REMARKS

AMENDMENTS TO THE DRAWINGS:

FIG. 1

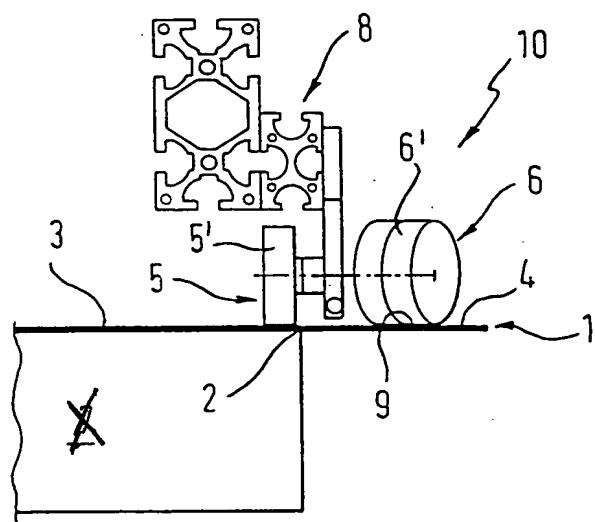
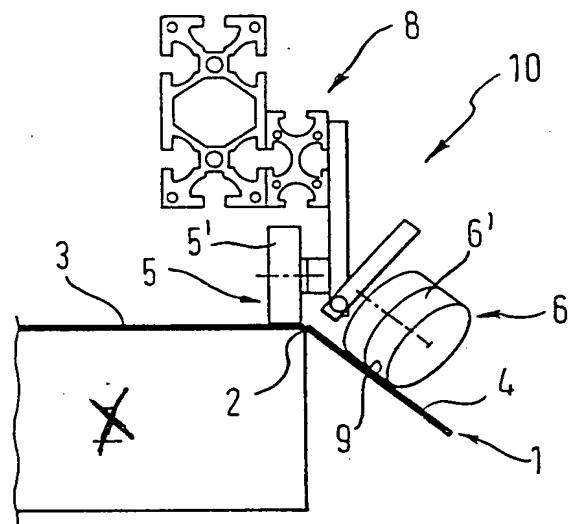
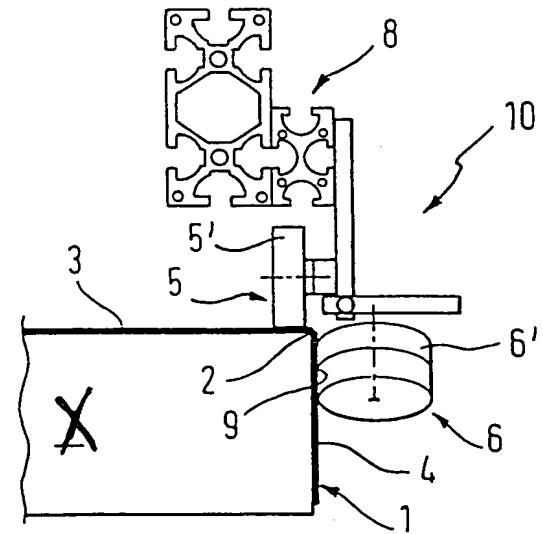
Also enclosed are proposed amendments to the drawings in red together with replacement drawings. Numeral 7 is deleted because it is not described in the specification.

The attached sheets of drawing include changes to Figs. 1-3.
